NTD-NRC-94-4259
DCP/NRC0184
Docket No.: STN-52-003

SUBJECT: WESTINGHOUSE RESPONSES TO NRC REQUESTS FOR ADDITIONAL
INFORMATION ON THE AP600

NTD-NRC-94-4259
ATTACHMENT A
AP600 RAI RESPONSES
SUBMITTED AUGUST 10, 1994

Figure 2A-32
Effect of P Wave Damping

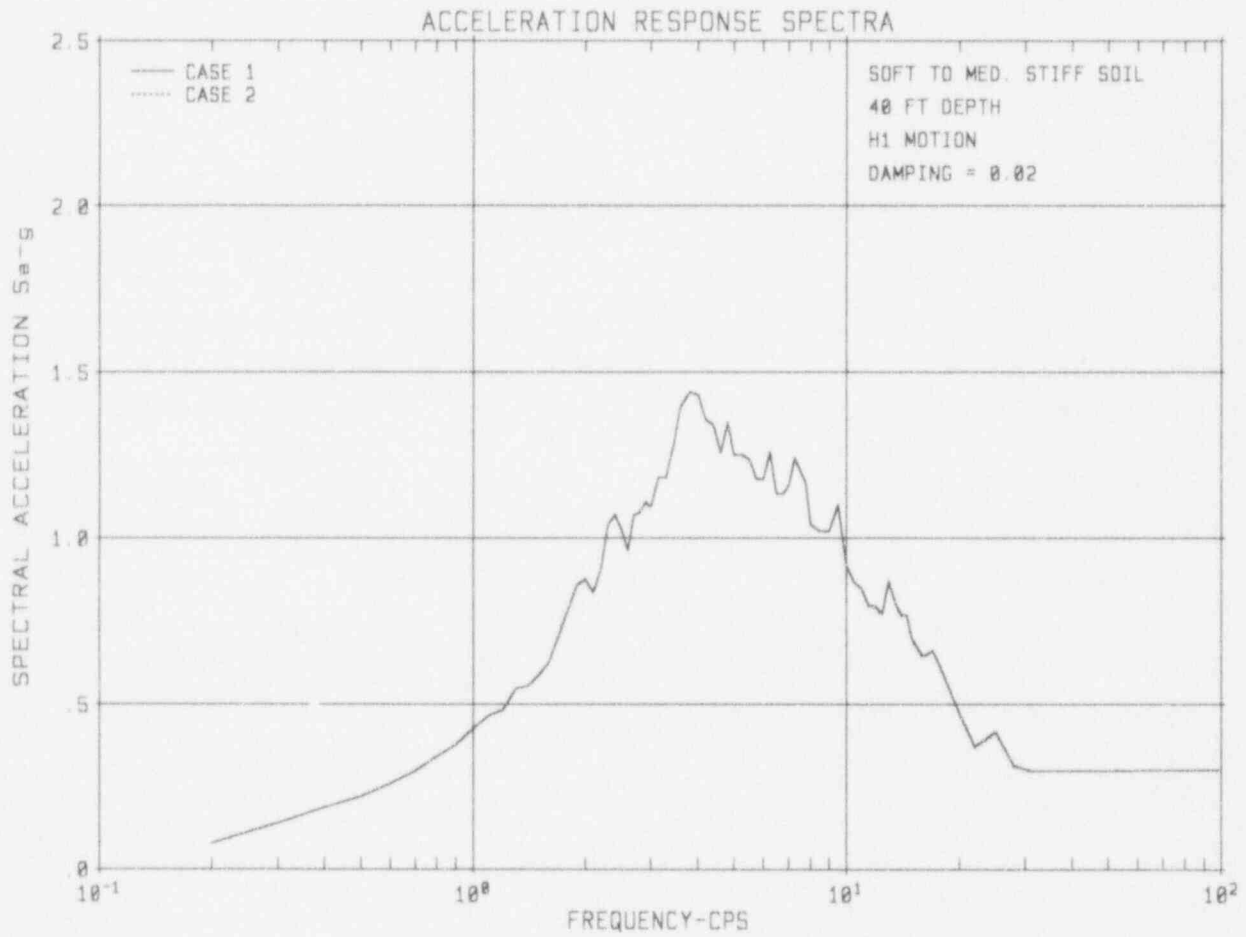
The soil column properties for horizontal and vertical (P-wave) models are not consistent. Specifically, (a) the damping ratio for S & P wave motions are different, and (b) Poisson's ratio for soils above the ground water table appear to be too high. Provide an explanation to justify (a) the use of same properties for the horizontal and vertical models, and (b) the use of a high Poisson's ratio in the analysis.

- a. The generic strain-dependent shear wave damping curves for soil/rock materials were obtained from a collection of laboratory test results as a function of shear strain amplitude. No comprehensive study to measure P-wave damping has been conducted. It is generally assumed that P-wave and S-wave damping are the same. This assumption was used for AP600. The following study was performed to evaluate the effect of P-wave damping:

The soft-to-medium soil profile with P-wave velocity of 5,000 ft/sec was analyzed using SHAKE in two cases. In Case 1, the P-wave damping was assumed to be the same as the S-wave damping (shown on Table 2A-10). In Case 2, the P-wave damping was computed using

The above relationship is based on zero dissipation for volumetric changes. The values for β_s and V_s were obtained from Table 2A-10 and V_p was assumed to be 5,000 ft/sec. If β_p was found to be less than 0.4 percent, the minimum of 0.4 percent was used. The response spectra in the free field at the depth of 40 ft corresponding to the basemat elevation are compared in Figure 230.63-1. The results are almost identical such that the curves for the two cases are essentially superimposed. The results are not affected by the P-wave damping ratio. This is due to the fact that the soil column frequency at 40 ft depth is larger than 31 Hertz and the input motion at ground surface is effectively retained at the basemat level in the free field. For this reason, use of smaller P-wave damping values is not expected to affect SSI responses significantly.

The generic strain-dependent shear wave damping curves for soil/rock materials were obtained from a collection of laboratory test results as a function of shear strain amplitude. No comprehensive study to measure P-wave damping has been conducted. P-wave and S-wave damping are assumed to be the same. A study was performed to evaluate the effect of P-wave damping. The soft-to-medium soil profile with P-wave velocity of 5,000 ft/sec was analyzed using SHAKE in two cases. In Case 1, the P-wave damping was assumed to be the same as the S-wave damping (shown on Table 2A-10). In Case 2, the P-wave damping was computed using

This relationship is based on zero dissipation for volumetric changes. The values for β_s and V_s were obtained from Table 2A-10 and V_p was assumed to be 5,000 ft/sec. If β_p was found to be less than 0.1 percent, the minimum of 0.1 percent was used. The response spectra in the free-field at the depth of 40 ft corresponding to the basemat elevation are compared in Figure 2A-32. The results are almost identical such that the curves for the two cases are essentially superimposed. The results are not affected by the P-wave damping ratio. This is due to the fact that the soil column frequency at 40 ft depth is larger than 31 Hertz and the input motion at ground surface is effectively retained at the basemat level in the free-field. For this reason, use of smaller P-wave damping values is not expected to affect SSI responses significantly.
